## Public Comment No. 1959-NFPA 70-2021 [ Global Input ]

**Public Comment No. 768-NFPA 70-2021 [ Global Input ]**

Figure 1: Example of Underground Corrosion of Copper Clad Steel

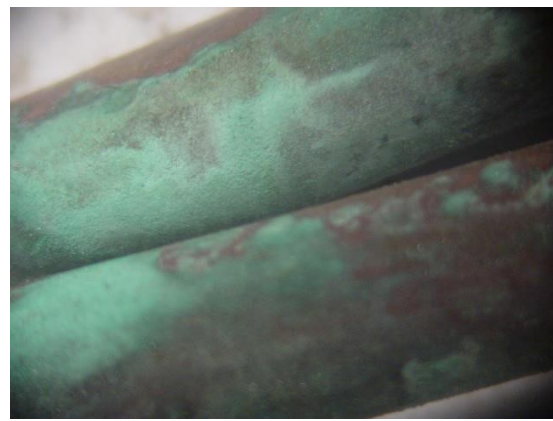
Copperweld has also conducted a 5-year study of buried bare 21% conductivity (copper thickness is 3% of the diameter) Copperweld® CCS in 10 different soil conditions in association with Southwest Research Institute<sup>2</sup>. The study reported 100% surface oxidation and various degrees of deterioration of the steel core as expected after 5 years. The exposed steel on the tip of the wire rusted and formed “scab”, as shown in Figure 1. The rust appeared to “seal-off” the un-oxidized material from the corrosive medium. The maximum depth of corrosion was 70% of the wire diameter.

Although the copper surface oxidation was heavy, the samples showed no signs of pits or holes in the copper cladding. The copper thickness of a severely oxidized 5-year sample showed no discernable difference when compared to an un-oxidized control sample that was not subjected to the corrosive environment. The mechanical and resistance testing

Figure 3: Copperweld® 40% LC DSA 7 No. 5 manufactured in 1962

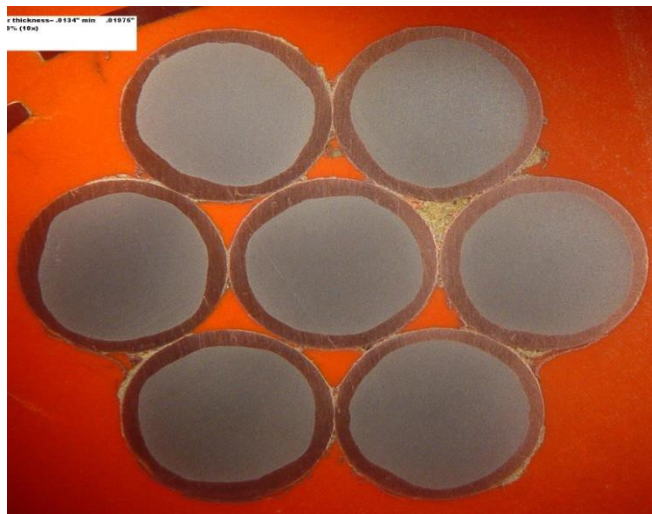
The 1962 conductors were manufactured by Copperweld with a nominal copper thickness of 10% of its diameter. Figure 3 shows the copper thickness ranges from 11.4 – 21.3 mils and the concentricity of the conductor averaged at 81.5%. Current manufacturing improvements yield concentricity of copper thickness above 85%.

Figure 4a: There is no visible corrosion between the copper and steel on all wires obtained from the substation in Kentucky.

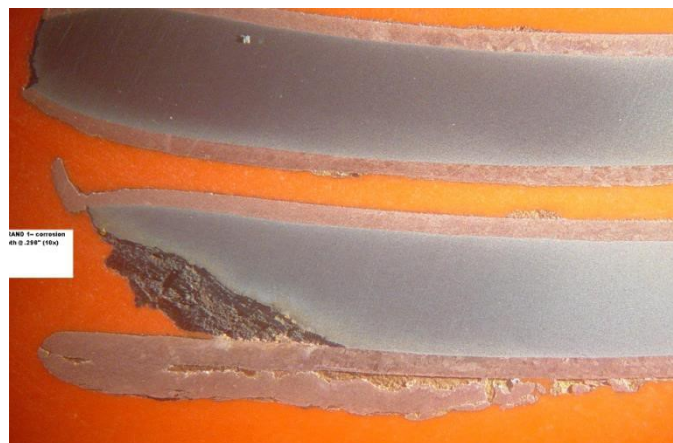
Figure 4a shows no visible corrosion observed other than oxidation and patination on the copper surface. At the ends of the wires, the corrosion occurred in the form of steel rust. The maximum depth of the corrosion is 0.859 inch with an average of 0.382 inch, as shown in Figure 4b.

Figure 4b: Corrosion occurred at the ends of the wires. Maximum penetration depth is 0.859 inch.
